APPLICATION NO.	FILING DATE	FIRST NAMED INVENTOR	ATTORNEY DOCKET NO.	CONFIRMATION NO.
10/723,309	11/26/2003	Christian Pacha	20195/0200609-US0	6833
7278	7590	06/24/2005	EXAMINER	
DARBY & DARBY P.C. P. O. BOX 5257 NEW YORK, NY 10150-5257			LAM, TUAN THIEU	
			ART UNIT	PAPER NUMBER
			2816

Office Action Summary

DETAILED ACTION

FIGURE 12

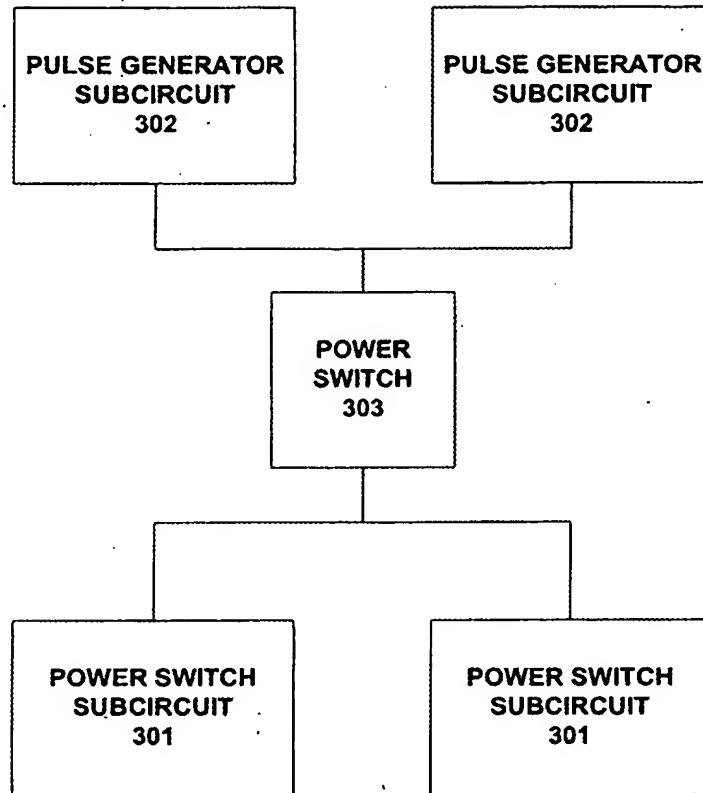
3. The disclosure is objected to because of the following informalities: the specification has failed to amend to include the description of the newly added figure 12 submitted on 5/12/2005.

Appropriate correction is required.
